Vehicle FIAT / Stilo 1.9 JTD 8V / 10/2001 - 12/2003 / Squareback/hatchback limousine  
 Country of manufacture I  
 Cubic capacity/Power 1.9 / 85 kW  
 Motor tag 192 A 1.000  
 RB key FIA 1618

### Bulletin

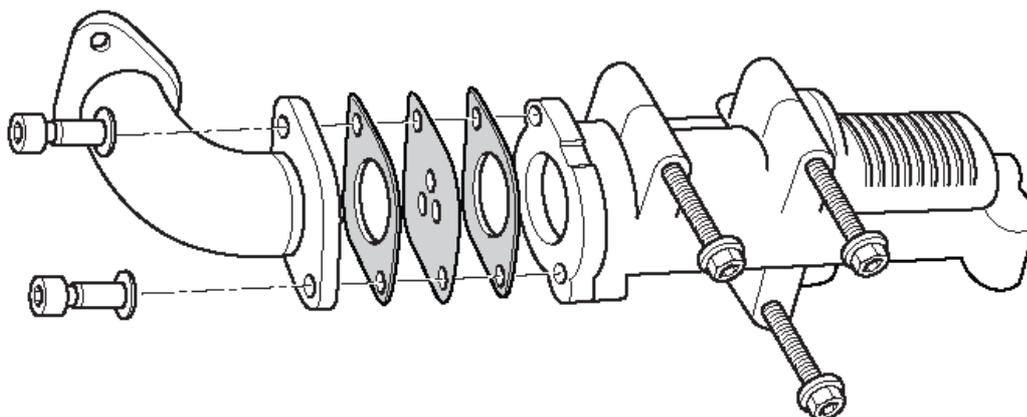
- Engine jerking.
- Hesitation when accelerating at 1800-2000 rpm.

- Exhaust gas recirculation (EGR) valve not operating properly.

- Check intake system for leaks.
- Check mass air flow (MAF) sensor.
- Check for oil in intake system.
- Check fuel injectors for leaks.
- Check fuel injectors for correct type.
- Ensure EGR system operates correctly.
- Remove EGR valve and fit restrictor plate:
  - 1,9D JTD/Multijet/16V/2,4D JTD 20V Fig.1.
  - 1,9D JTD 8V Fig.2.
